Village of Arlington Heights
Plan Commission
Board Room
Arlington Heights Village Hall
33 S. Arlington Heights Road
Arlington Heights, IL 60005
September 26, 2018
7:30 PM

VILLAGE OF ARLINGTON HEIGHTS **STAFF DEVELOPMENT** **COMMITTEE REPORT**

File Number: PC #18-017
Project Title: 1104 S. Arlington Heights Rd.
 Land Use Variation Amendment
Address: 1104 S. Arlington Heights Rd.
PIN: 08-09-215-008

Project Number: PC 18-016
Project Title: 614 N. Haddow Ave Lot Consolidation
Address: 608-614 N. Haddow Ave.
PIN: 03-29-123-006, 03-29-123-017

AS-1

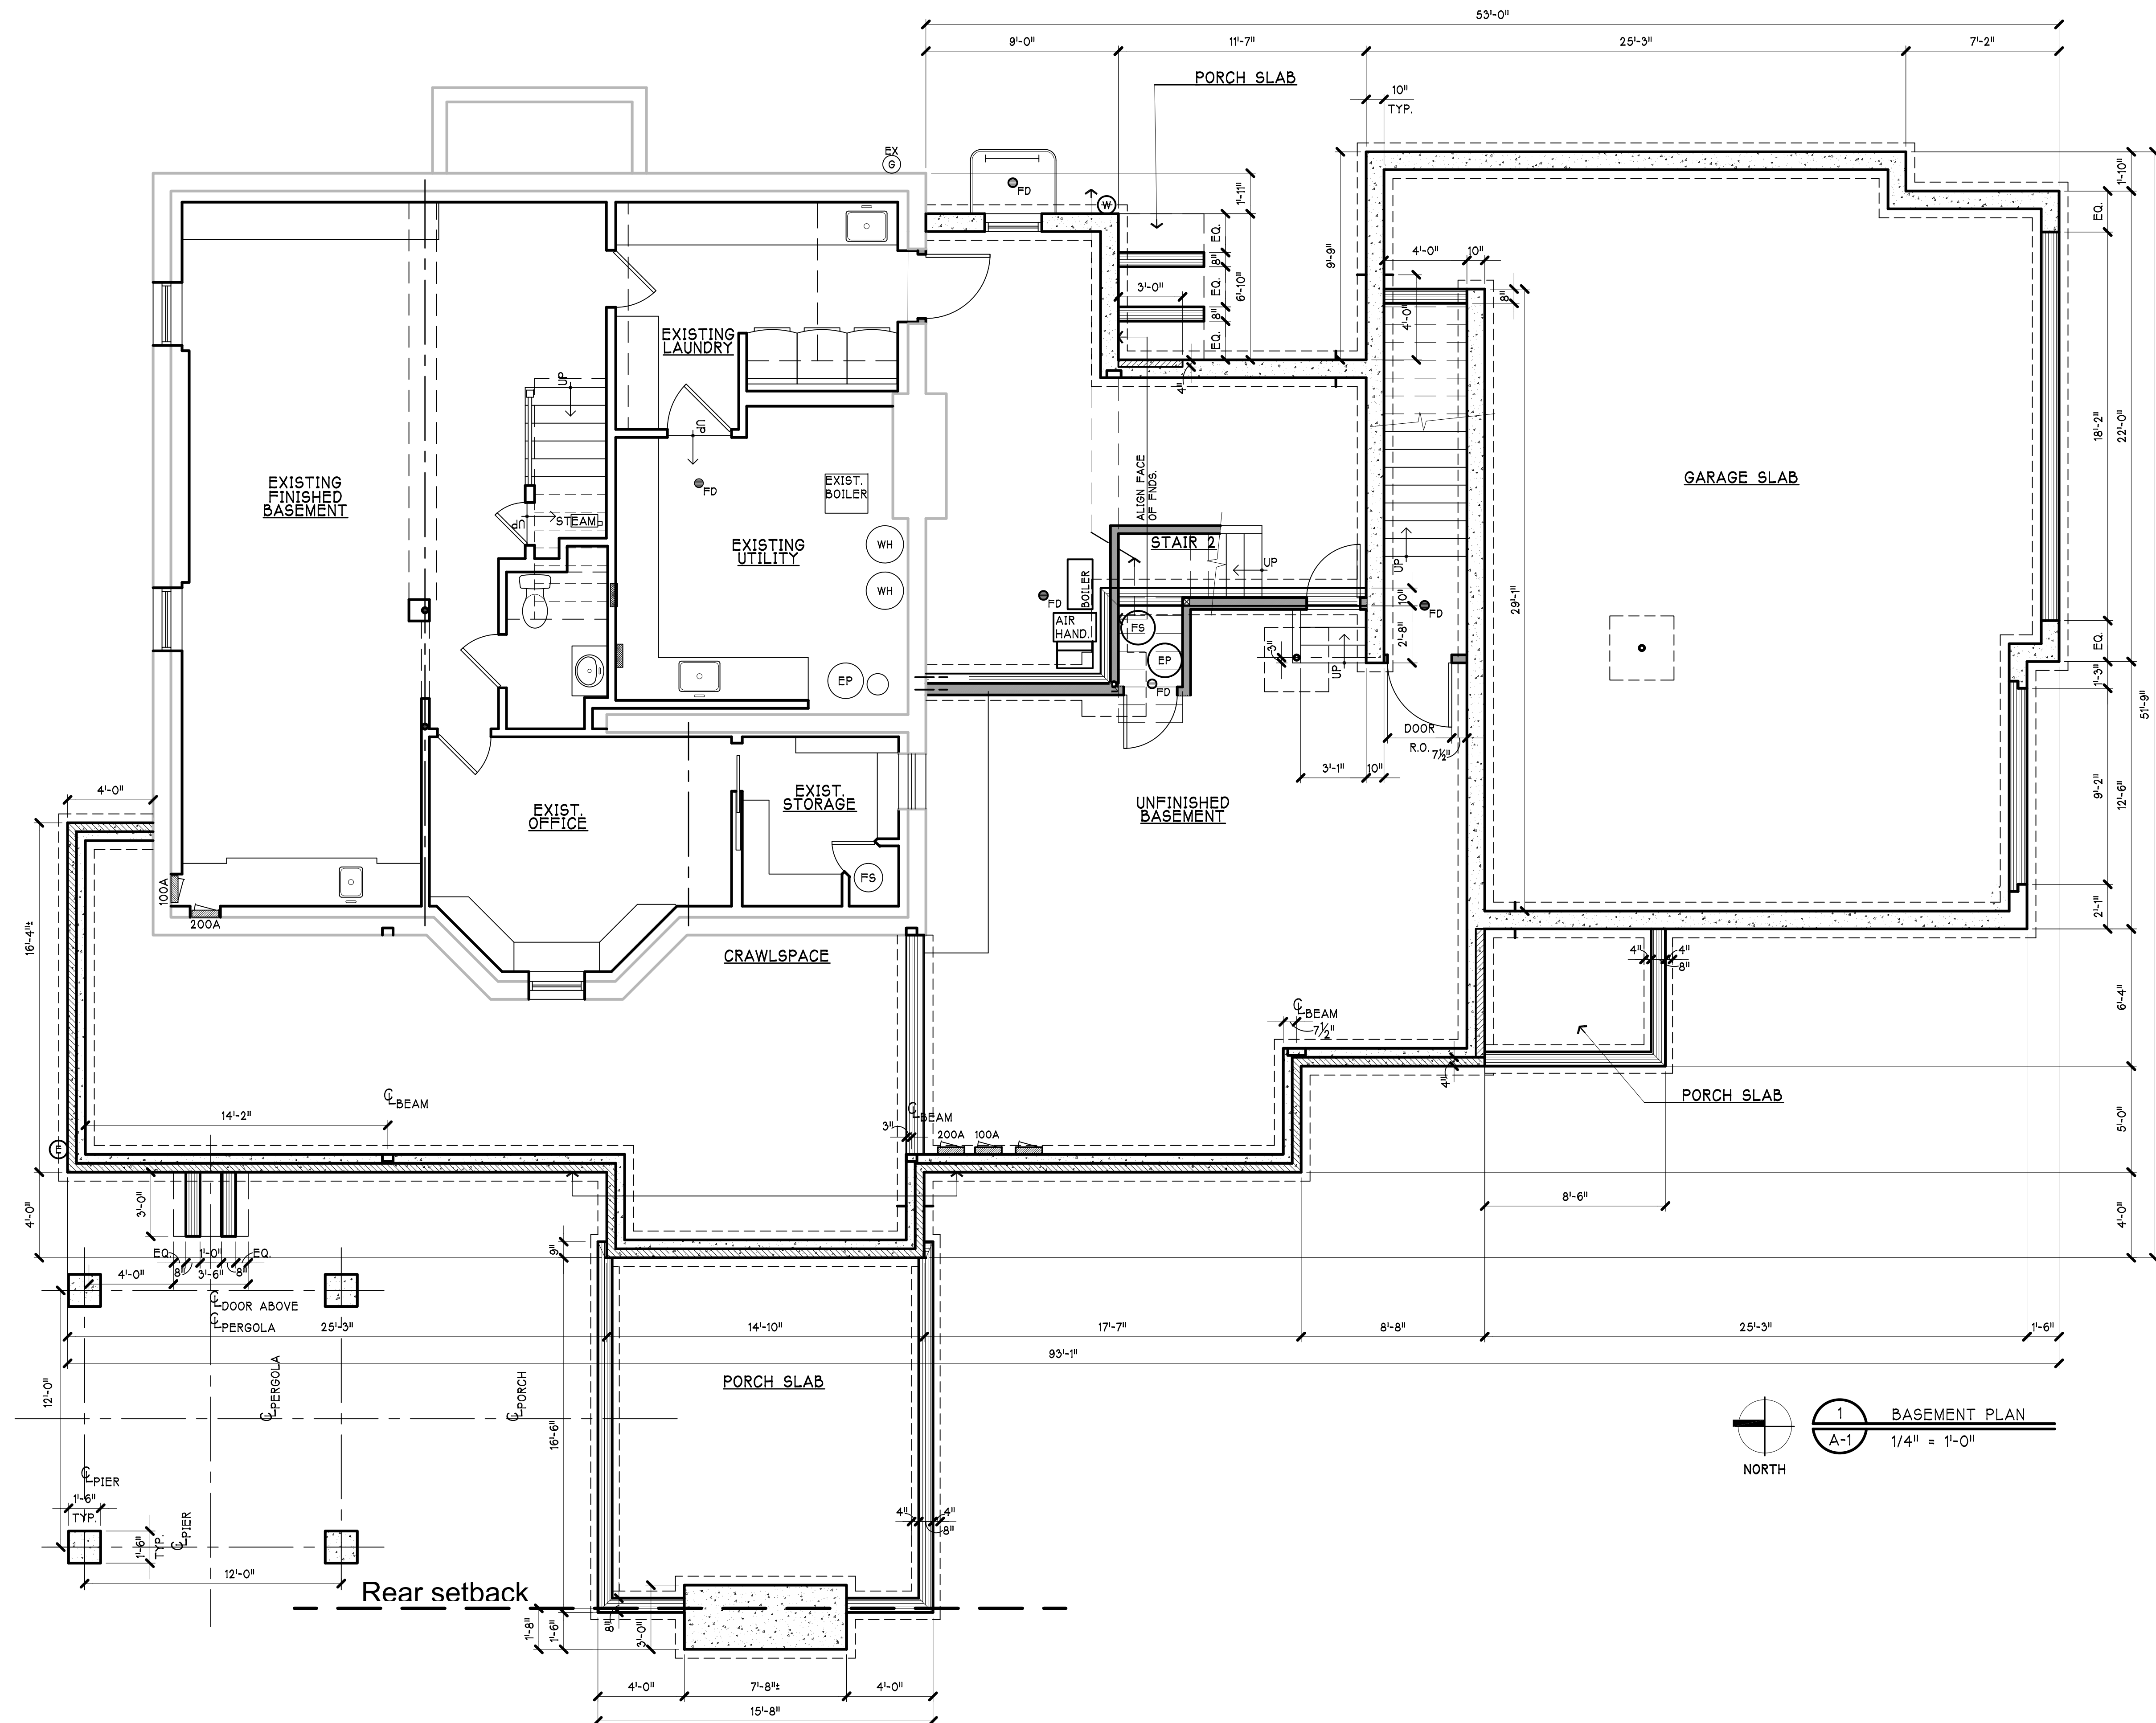
19. Revised front yard setback to the established average. Included additional note clarifying the actual required setback dimension. See Plat of Resubdivision, sheet #1. Also, included setback calculation. See AS-1.
